CPUC SUBSTATION AUDIT FINDINGS REPORT RESPONSE
PG&E Cupertino Headquarters
January 27 – 31, 2025

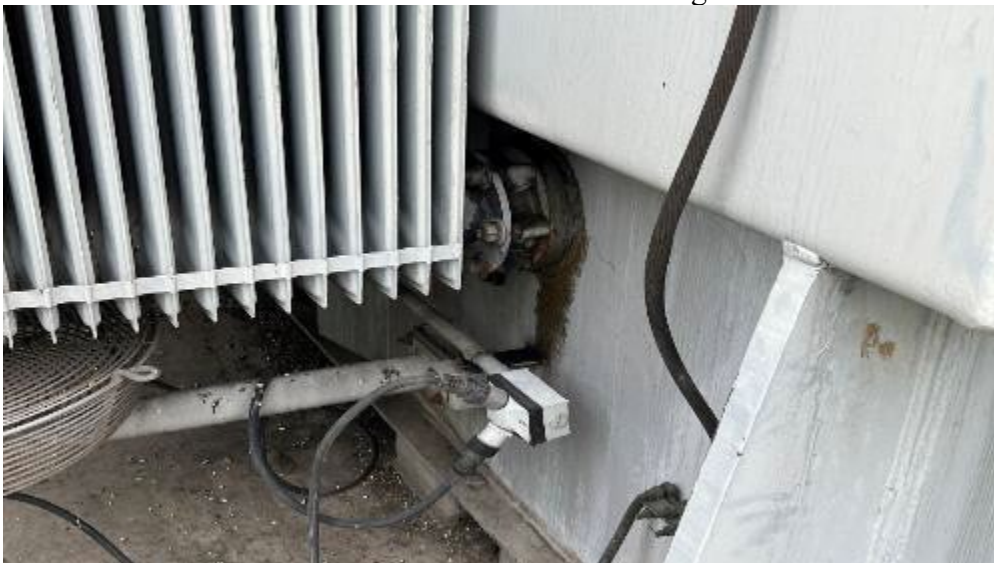
6.2 Transformer Bank 1 Sample Drain Valve Oil Leak Mitigation Existing LC Tag#129692374.

We agree that Transformer Bank 1 sample drain valve had an oil leak at El Patio Substation. This nonconformance had a pre-existing LC notification, 129692374, that was established in our system of record, SAP, prior to the field audit. We do not agree that this finding qualifies as a violation of GO 174, Rule 12 since this LC notification was worked in accordance with our maintenance procedures and completed on February 14, 2025.

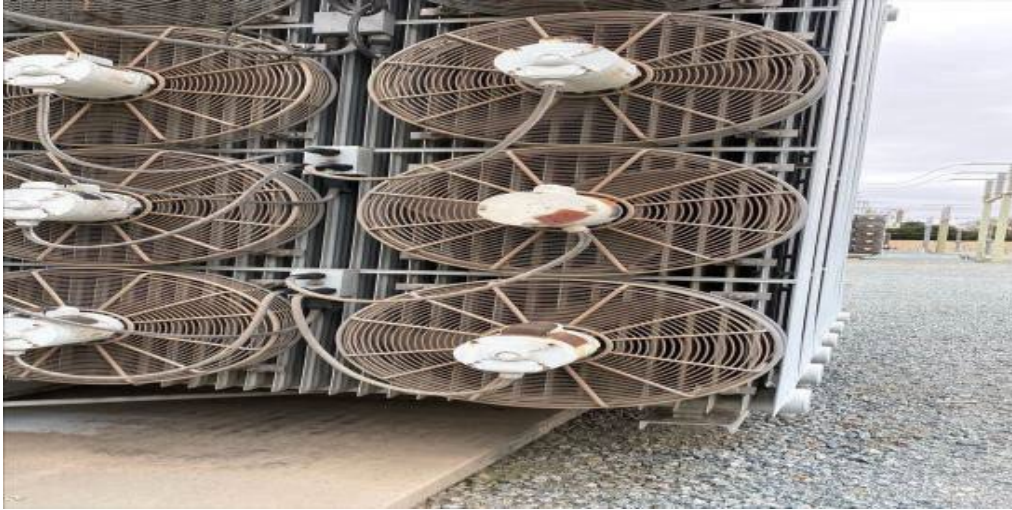
7.3 Transformer Bank 4 Oil Leak Mitigation Existing LC Tag#130535750.

We agree that Transformer Bank 4 had oil leak mitigation at Hicks Substation. This nonconformance had a pre-existing LC notification, 130535750, established in our system of record, SAP, prior to the field audit. We do not agree that this finding qualifies as a violation of GO 174, Rule 12 since this LC notification was worked in accordance with our maintenance procedures and completed on March 5, 2025.

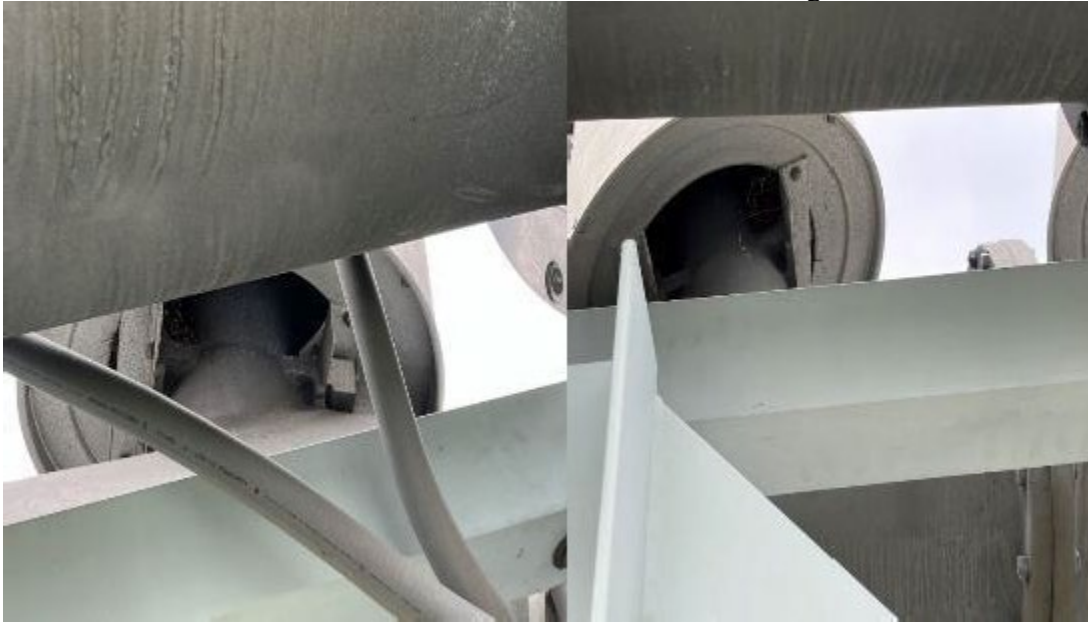
11.1 Circuit Breaker 142 has Faded Semaphore. Existing LC Tag#130791452.
